RE: Brady Corporation

FCC ID: NUC-BC1000  
IC: 3287A-BC1000

ATCB021484

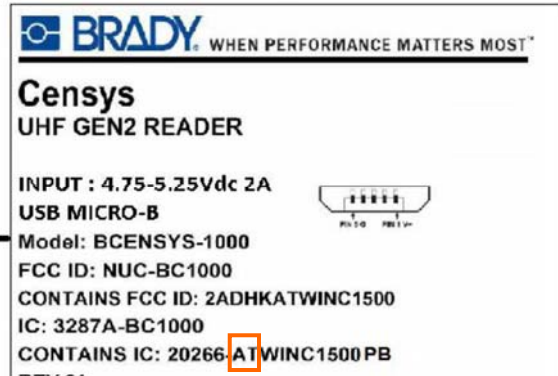
- 1) I hate to bear bad news, but it seems the labeling of the additional module from the most recent uploads just provided (Manual, Internal Photos, and Final Host Labeling) still is incorrect. If the information as cited is from a production version, it still seems to have a problem. The IC ID Number still does not match (there is a preceding AT that was not included on the certification number):  
Internal Photos:

Manual:

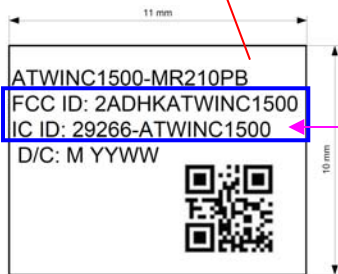
CONTAINS FCC ID: 2ADHKATWINC1500  
CONTAINS IC: 20266-ATWINC1500PB
